**لتلزم الأعمال اللازمة لاستكمال وتأهيل مدرسة جورة ترمس الرسمية
الواقعة في كسروان جبل لبنان**

Addendum No 1

Answers to Bidders Clarifications

Fence wall for courts

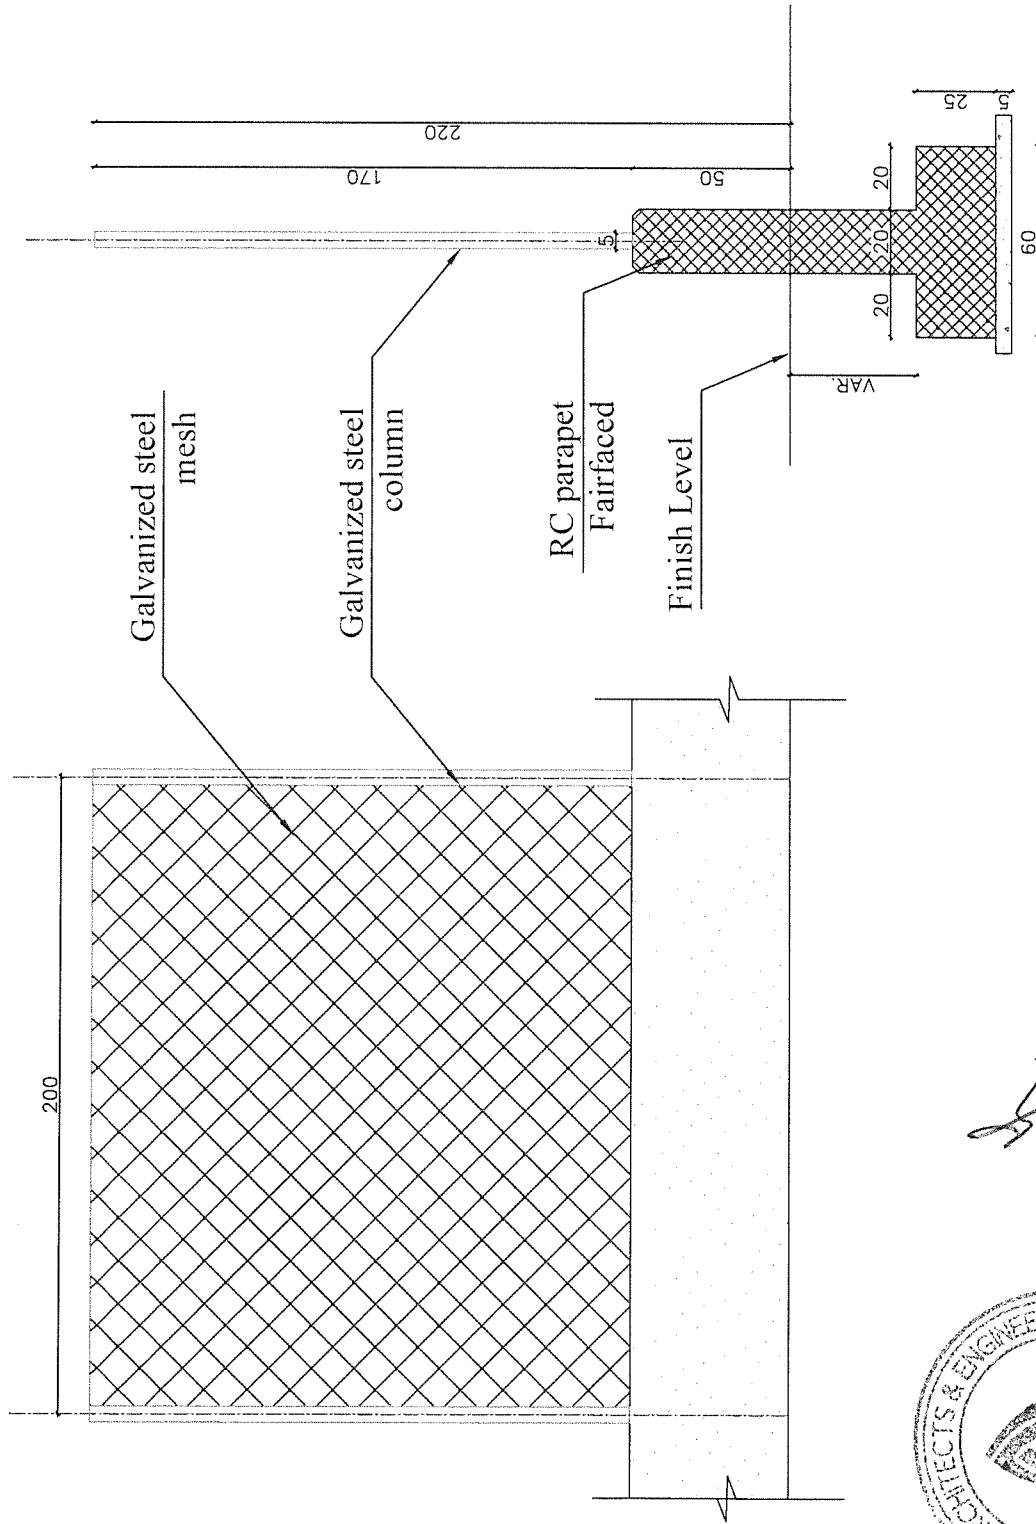
4	البند رقم 2.5.1 المتعلق بالباطون المسلح هل هو بالمتر المربع او المتر المكعب؟	ان البند رقم 2.5.1 المتعلق بالخرسانة المسلحة هو بالمتر المكعب
5	Please provide us with the details of the playground fence and handrail.	Please refer to the attached preliminary sketch
6	عطفا على الملحق رقم (٦): تصريح بمعاينة مواقع العمل نافي للجهة، الذي يتوجب ان يقع من قبلكم، هل يمكنكم افادتنا بمعلومات عن معاينة مواقع العمل (الزمان، المكان، نقطة التجمع، الاحداثيات، الخ...)	لا يوجد موعد محدد أو زيارة ميدانية إلزامية ينظمها مجلس الإنماء والإعمار لمعاينة موقع المشروع. ويمكن للعارضين، وعلى مسؤوليتهم الخاصة، إجراء معاينة للموقع في أي وقت قبل موعد تقديم العروض، بما يساعدهم في إعداد عروضهم، وذلك عملاً بما ورد في الملحق (المرفق) رقم (٦) من دفتر الشروط المتعلق بالتصريح بمعاينة موقع العمل نافي للجهة، ولا يتطلب ذلك تنسيقاً مسبقاً مع مجلس الإنماء والإعمار، ولستم بحاجة الى توقيع الملحق (المرفق) رقم (٦) من قبل المجلس.
7	Kindly provide us with the dimensions and locations of the wooden doors and aluminum windows to be installed.	Wooden doors are for all rooms on the floor, while aluminum doors are for the balcony and interior bathroom doors; dimensions are based on actual site measurements.
